**SB18-C-001A**

## **DOOR WIND NOISE/WATER INTRUSION – IMPROVED DOOR SEAL AND ADJUSTMENT PROCEDURE**

***This bulletin is being revised to update affected model years and supersedes bulletin SB18-C-001. Please discard bulletin SB18-C-001.***

**Figure 6**

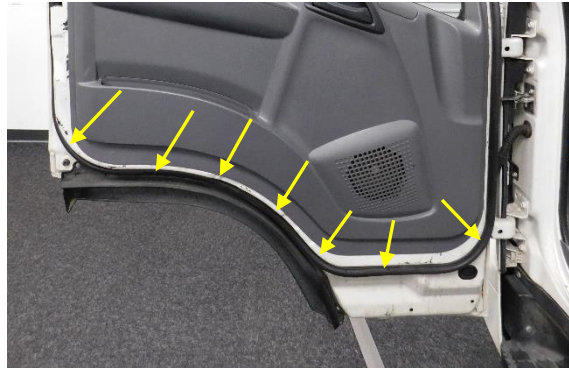
3. Wipe down seal mounting surface using a clean cloth.
4. Attach the new door seal:
  - Start at the top, outside corner, as shown by red arrow in Figure 6.

- Fasten the seal, working across the top of the door and working to the bottom – see yellow arrows in Figure 6.
- Go back to the top corner and connect the seal down the opposing side of the door, working towards the bottom.
- Now fasten the seal across the bottom, as shown by yellow arrows in Figure 7.

**Figure 8** – Offset Measuring Sections S, F & K

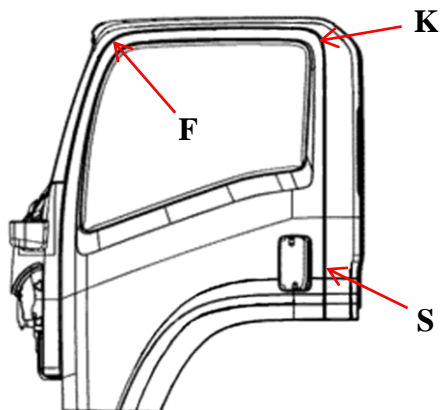
6. Measure the offset of the doors at the locations shown in Figure 8. Specifications are shown in Table 1. Measurements are made using two metric rulers as shown in Figures 9, 10 & 11.

TABLE 1		
Door Surface Offset Specifications		
Location	Measurement	
F	3.3mm	+/- 1.5mm
K & S	0.0mm	+/- 1.5mm

**Figure 14**

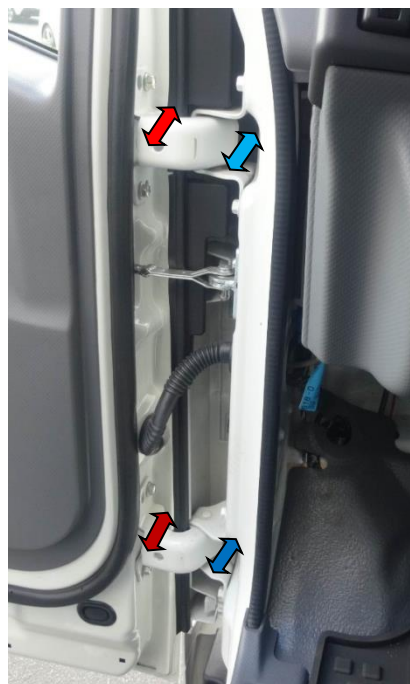
10. Loosen bolt Number 1 shown in Figure 14 using a 3/8" drive ratchet, a 1" long-3/8" drive extension, and a 12mm crow's foot. After the bolt is loose, remove the bolt using a 12mm wrench. Replace bolt Number 1 with a new bolt, the part number for which is provided on the last page of this bulletin.

12. Repeat Steps 8 through 11 for bolts 2, 3, and 4. (See Figure 14.)

14. When the doors have been adjusted correctly, torque all the door bolts to the specified torque using a 3/8" drive torque wrench, a 1" long-3/8" drive extension, and a 12mm crow's foot. Tightening Torque - 21.6 N•m (15.9 lb•ft)
